**Transmission Symptom - Transmission Oil Leaks Out When Driving on Race Circuits:
Replacing Vent Line for Clutch Chamber (SY 130/19)**

Vehicle Types: **911 GT3 (991)/911 GT3 RS (991)**

Subject: **Vent line for clutch chamber**

Vent line for clutch chamber

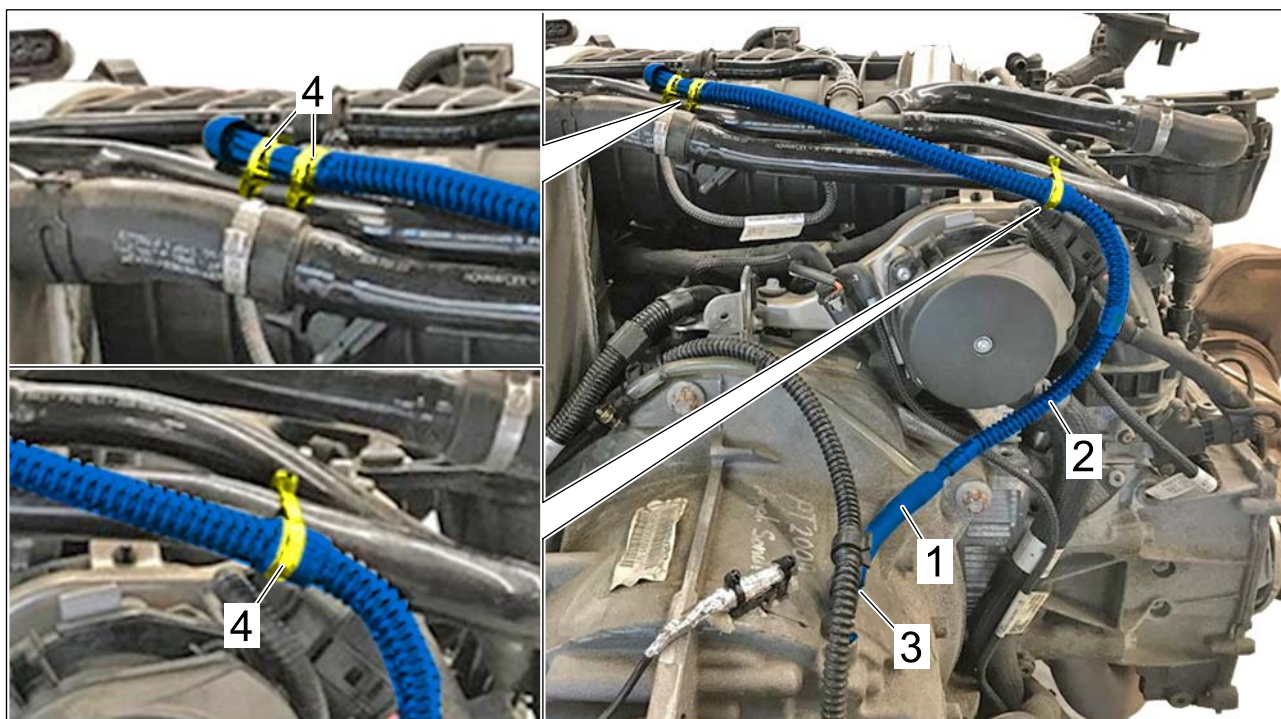
Work Procedure: 1 Disconnect vent line for clutch chamber ⇒ *Vent line for clutch chamber -1-* from breather pipe ⇒ *Vent line for clutch chamber -2-*.

2 Replace vent line for clutch chamber.

2.1 Install **new** hose adapter (9GT301280) ⇒ *New vent line for clutch chamber -1-* on **new** vent line for clutch chamber (9GT301063) ⇒ *New vent line for clutch chamber -2-* and breather pipe ⇒ *New vent line for clutch chamber -3-*.

2.2 Route **new** vent line for clutch chamber (9GT301063) ⇒ *New vent line for clutch chamber -2-* so that it is routed continuously upwards as shown and secure with combination holders at positions ⇒ *New vent line for clutch chamber -4-*.
